Preliminary Information

PIP5631 10L80 Additional Instructions For Control Valve Body Bolt Kit Part Number 24294356

Callout 6: Valve body assembly

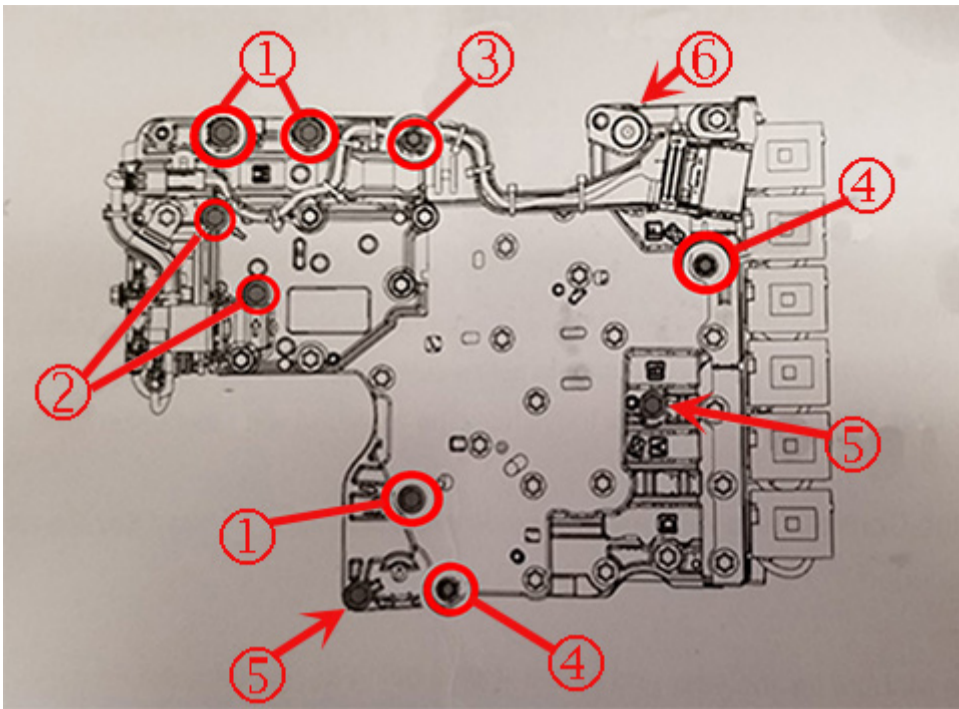
Not all valve body bolts require replacement when removed as the instruction sheet indicates: The following provides additional direction on which bolts require replacement when removed.

Callout 1: Item 375 in SI document 4970174 (Qty3) – replacement required. Seven (375) bolts are included in Bolt Kit 24294356. Only 3 are required. Contain a preapplied sealant.

Callout 2: Item 376 in SI document 4970174 (Qty 2) – replacement not required. Sealant not required.

Callout 3: Item 377 in SI document 4970174 (Qty1) replacement not required unless removed. Bolt is not typically removed during valve body replacement.

Callout 4: Item 19 in SI document 4970174 (Qty2) replacement required. Filter retaining bolts.

Callout 5: Item 320 in SI document 4970174 (Qty 2) replacement not required. Sealant not required.

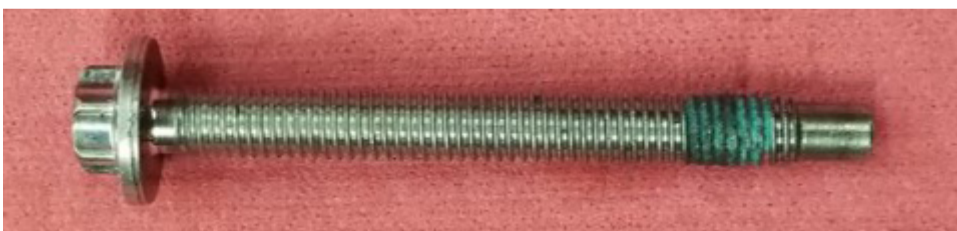
Note: New item 375 bolts on the left removed bolts on the right.
